Medworth Energy from Waste Combined Heat and Power Facility

PINS ref. EN010110
Document Reference: 15.2
Revision 1.0
July 2023

Written Summary of the Applicant's Oral Submissions at ISH6

Figure 1: Vehicle Tracking EfW Site Closed.

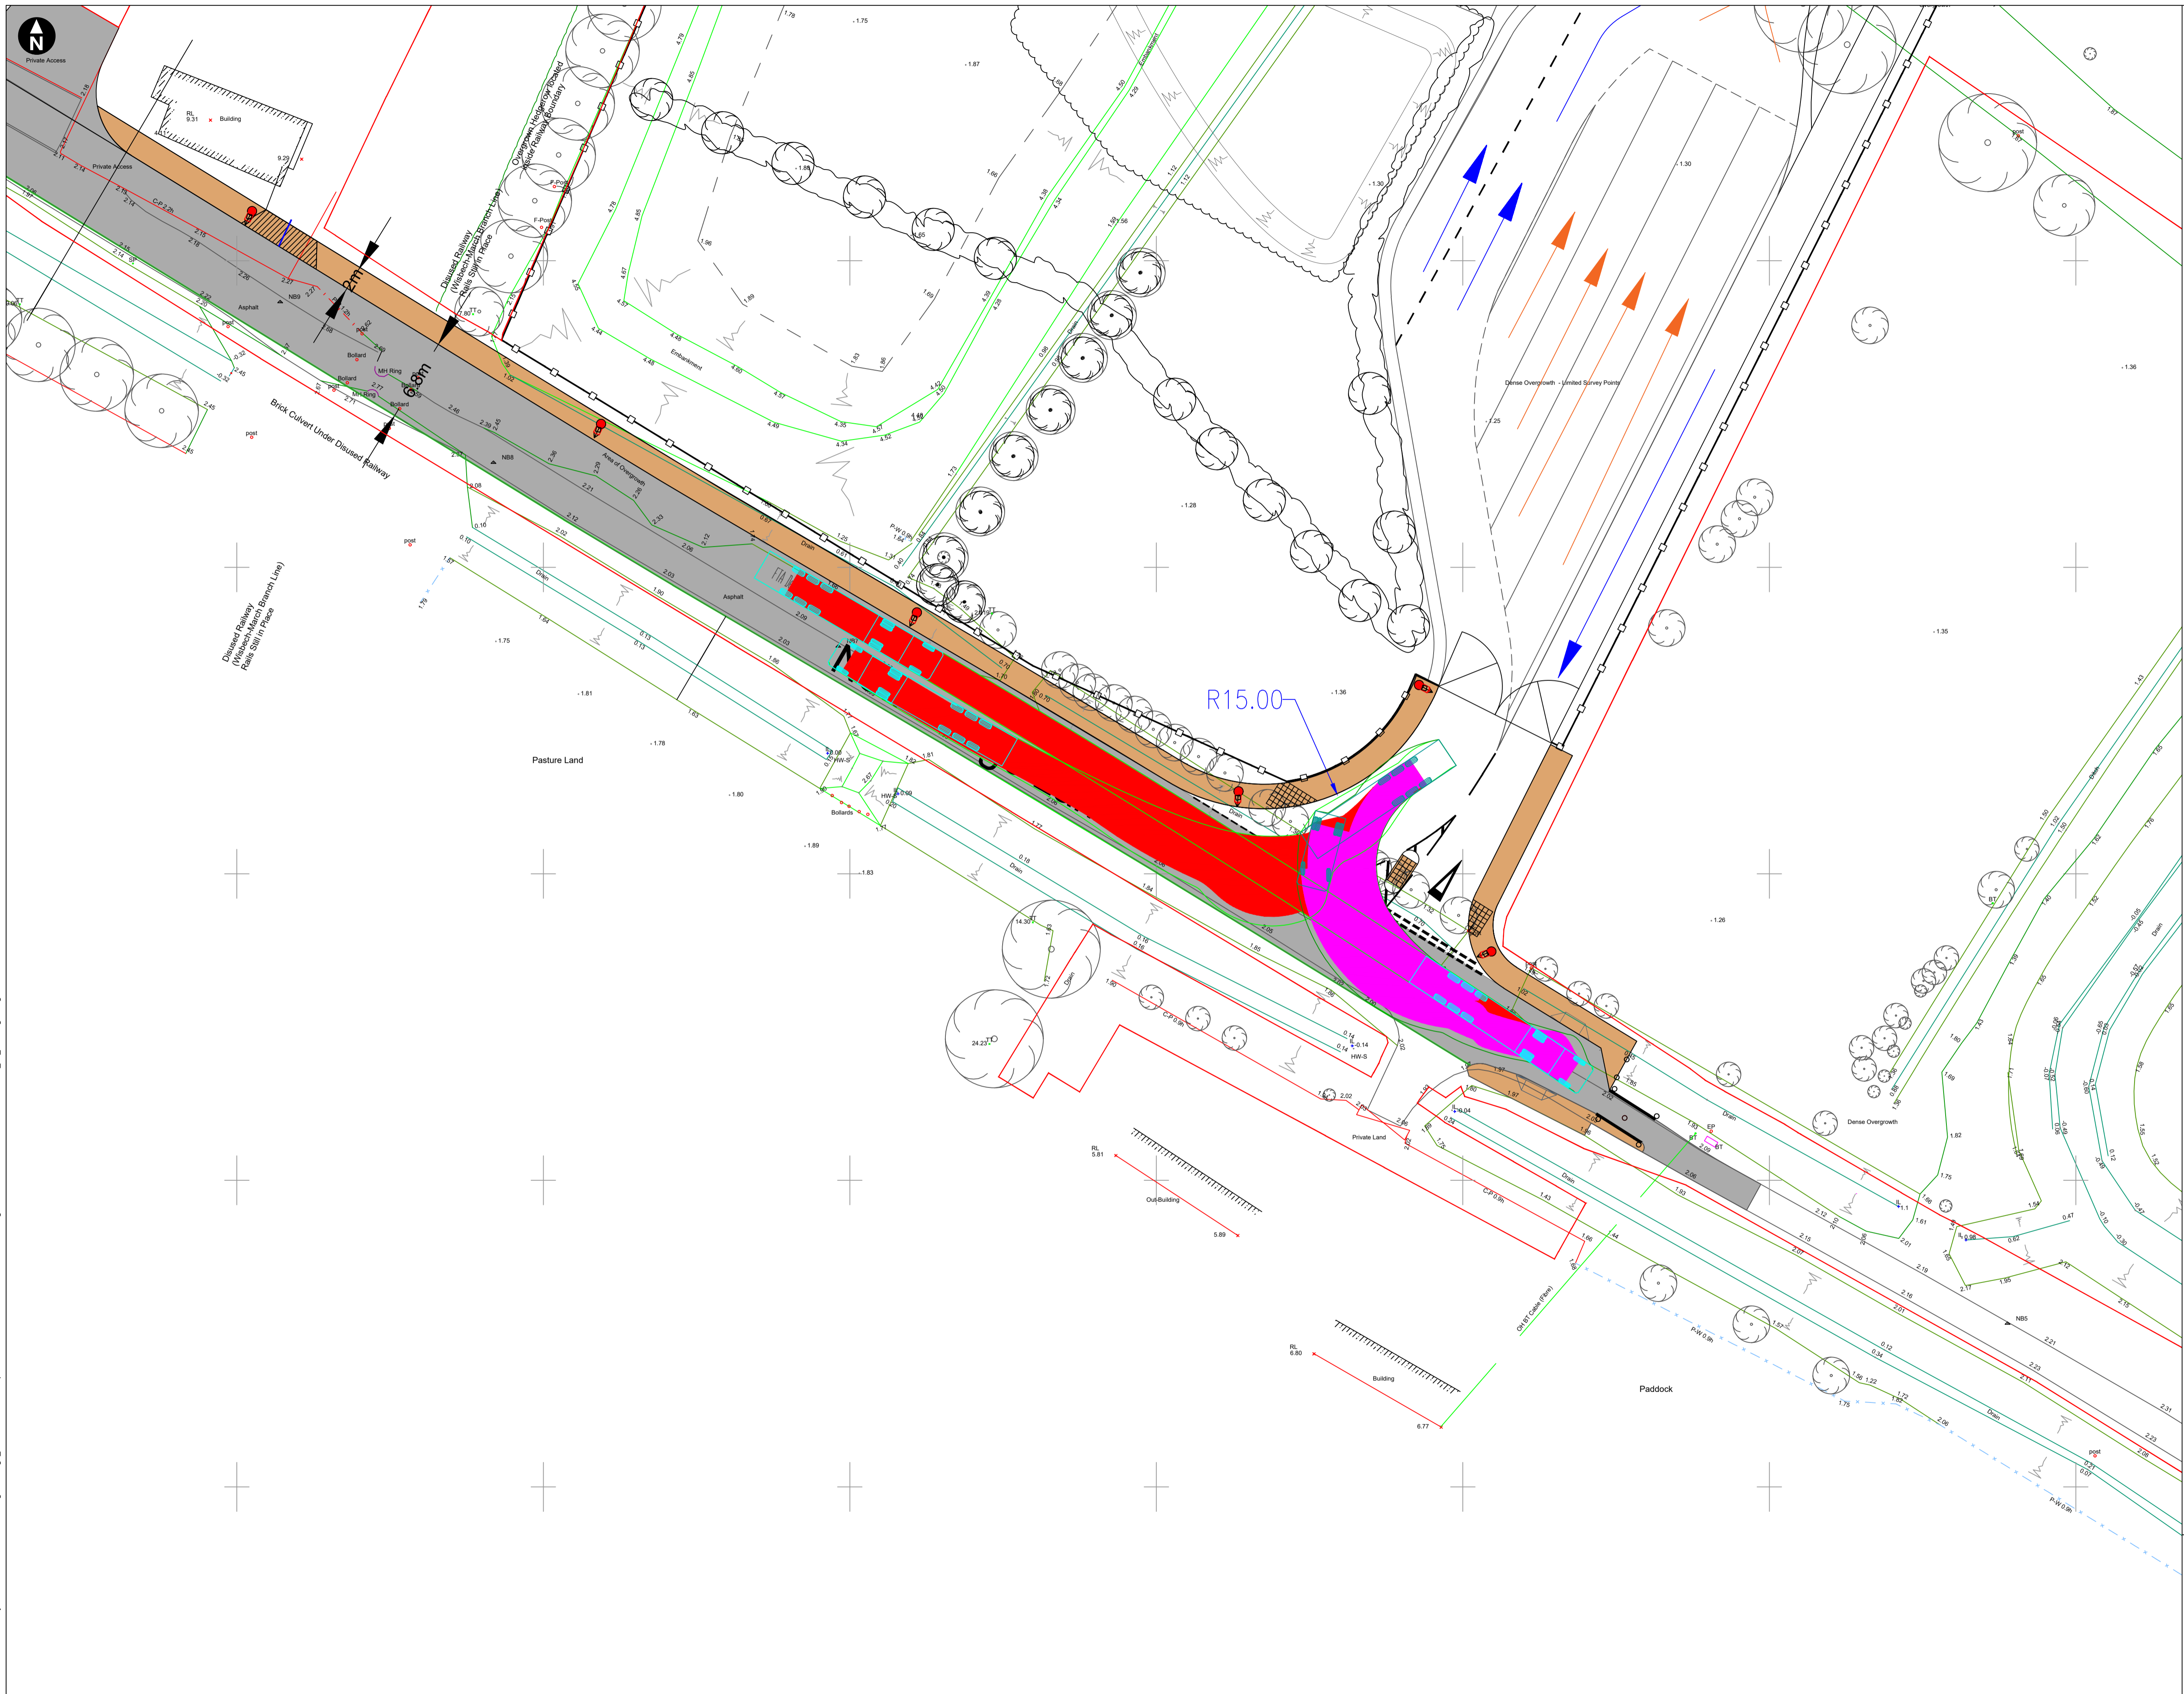
4	Applicant	Applicant to provide confirmation that vehicles would have enough ground to manoeuvre and turn around whilst the gates are closed.	6	<p>The Applicant has prepared a swept path analysis to confirm that a HGV delivery vehicle can manoeuvre and turn around when the gates are closed. See Figure 1 at the end of this document.</p>
5	Applicant and CCC	To continue to engage in relation to road maintenance and potential contributions and update the ExA until an agreement has been reached.	6	<p>The Applicant has and will continue to engage with CCC Highways on the matter of road maintenance and contributions. It is confident that agreement will be reached before the close of the Examination.</p>
